Date: July 18, 2003

From: George Penokie (IBM/Tivoli)

Subject: SPC-3: Persistent All Registrants Fix Part 2

Figure 1 — Device server interpretation of PREEMPT service action

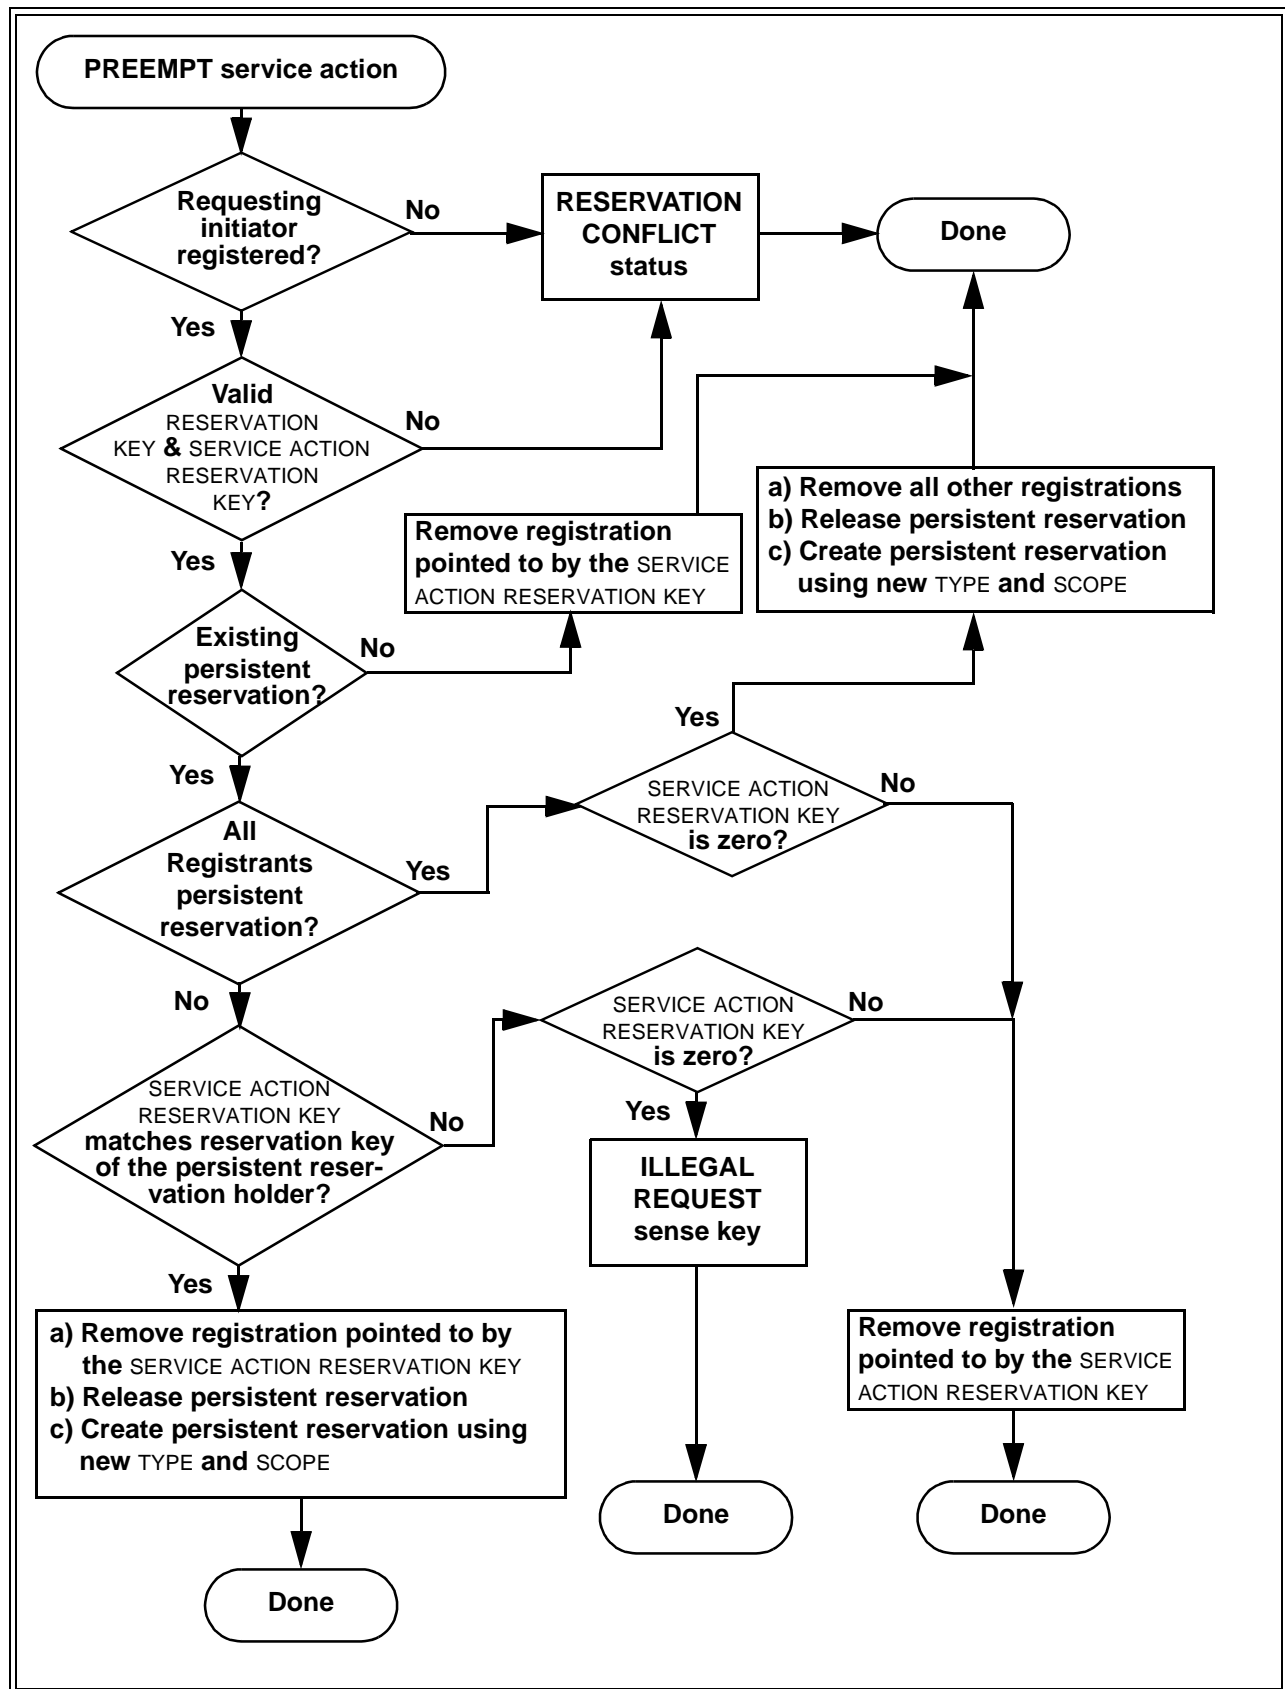
In the PREEMPT flowchart in spc3r05 and earlier, the "Existing persistent reservation? no" question lead to "Remove registration pointed to by the service action reservation key." When All Registrants was added in spc3r06, the arc was changed to go straight to "Done".

How should PREEMPT and PREEMPT AND ABORT be handled if there is no persistent reservation at all? Do nothing (per spc3r05), or go ahead and remove the specified registrations and (for PREEMPT AND ABORT) abort the related tasks (per spc3r06+)?

There doesn't seem to be much supporting text for the spc3r06+ figure except for the first 7 words in 5.5.2.7.4.4: "If there is a persistent reservation and if the SERVICE ACTION RESERVATION KEY field does not identify a persistent reservation holder the device server shall perform a preempt by doing the following in an uninterrupted series of actions:". This phrase was added in spc3r13 per 03-094r3 to better match the (possibly broken) figure 3.

I think the original behavior of "remove registrations (and abort tasks)" might make more sense.

It looks to me like the line in the flow chart is wrong. The text from 03-094r3 assumed (incorrectly it appears) that the flowchart was correct. Also, it appears a line of text from 03-094r3 was not placed into SPC-3. It stated (again incorrectly):

I believe the flowchart should be fixed (as shown below) and the paragraph that was not placed into SPC-3 not be placed into SPC-3. The paragraph in section 5.5.2.7.4.4 Removing registrations:

If the SERVICE ACTION RESERVATION KEY field does not identify a persistent reservation holder, or there is no persistent reservation holder (i.e., there is no persistent reservation), the device server shall perform a preempt by doing the following in an uninterrupted series of actions:
